APPLICATION NO.	FILING DATE	FIRST NAMED INVENTOR	ATTORNEY DOCKET NO.	CONFIRMATION NO.
10/807,040	03/23/2004	Takashi Akita	04995/140001	2727
75	90 10/19/2005		EXAM	INER
Jonathan P. Os	sha	FERGUSON, MICHAEL P		
Osha Novak &	May L.L.P.			
Suite 2800			ART UNIT	PAPER NUMBER
1221 McKinney St.			3679	
Houston, TX 77010			DATE MAILED: 10/19/2005

· // _					
	Application No.	Applicant(s)			
Office Assistant Communication	10/807,040	AKITA, TAKASHI			
Office Action Summary	Examiner	Art Unit			
	Michael P. Ferguson	3679			
The MAILING DATE of this communication apperiod for Reply	pears on the cover sheet with the	correspondence address			
A SHORTENED STATUTORY PERIOD FOR REPL WHICHEVER IS LONGER, FROM THE MAILING D - Extensions of time may be available under the provisions of 37 CFR 1. after SIX (6) MONTHS from the mailing date of this communication. - If NO period for reply is specified above, the maximum statutory period - Failure to reply within the set or extended period for reply will, by statute Any reply received by the Office later than three months after the mailin earned patent term adjustment. See 37 CFR 1.704(b).	ATE OF THIS COMMUNICATION (136(a). In no event, however, may a repl

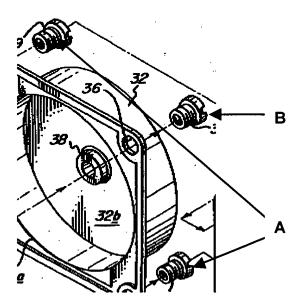
As to claim 1, Low discloses an attachment structure of a rear panel to a tuner, in which a rear panel 20 is attached and fixed onto a front surface of a tuner 30, the tuner having two connector connection parts A (Figure 1 reprinted below with annotations) protruding in front and a small protrusion B with a tapped hole for panel attachment provided in a middle position between the connector connection parts, the attachment structure comprising:

the rear panel having two holes **26** for inserting the connector connection parts in portions corresponding to the two connector connection parts of the tuner and a small cylindrical part **23** that is formed protrusively to the tuner side in a portion corresponding to the small protrusion with the tapped hole of the tuner; and

wherein the two connector connection parts of the tuner are inserted into the two holes of the rear panel, and a leading end of the small cylindrical part is brought into contact with a front surface of the small protrusion with the tapped hole of the tuner, and

under this state, the male screw is inserted into the small cylindrical part from the front surface side of the rear panel and further a leading end of the male screw is screwed into the tapped hole of the small protrusion with the tapped hole of the tuner, whereby the rear panel is attached and fixed onto the front surface of the tuner (Figures 1 and 2B).
